Technical Service Bulletin

NUMBER: 08-20-00

Horn Inoperative Or Sound Is Weak Or Muted

2000 (PL) Neon

FIGURE 1

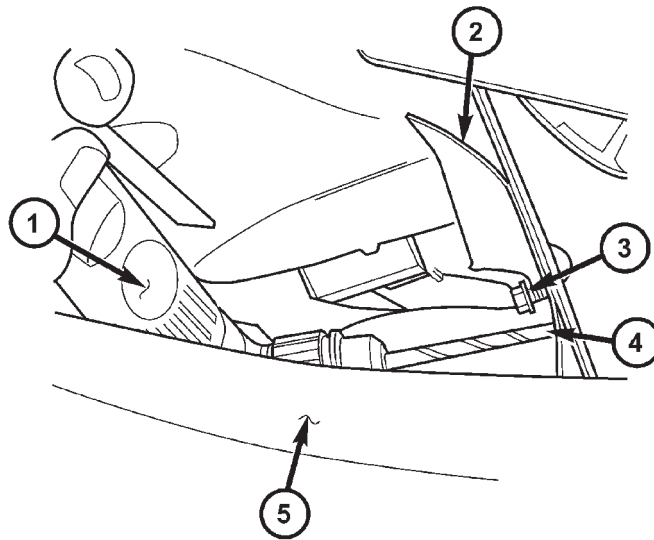
Due to horn orientation, water may enter the horn interior and cause damage. The horn may not work or the customer may report that the horn sounds quieter than before.

2. Remove the far right screw of the grill emblem where it attaches to the head lamp module housing.
3. Remove the two screws attaching the right headlamp module to the upper crossmember.
4. Pull the right headlamp module out and remove the connectors.
5. Remove the headlamp module from the vehicle.
6. Disconnect and remove the horn. Discard the horn.
7. Cut out the template provided in the kit.
8. Install the template and hold it in place by inserting the horn mounting bolt in its original position through the template. Mark the location of the new hole through the template.
9. Using a 6.5–mm (.25 in.) drill bit and an angle drill, drill a hole through the sheet metal at the point marked in step 8 (Figure 1).

10. Position and install the new horn using the original bolt hole. The new hole drilled in step 9 is for the anti–rotation tab on the new horn. The horn will now be approximately horizontal.
11. Install the headlamp module assembly and the grill emblem screw.
12. Install the battery negative cable.
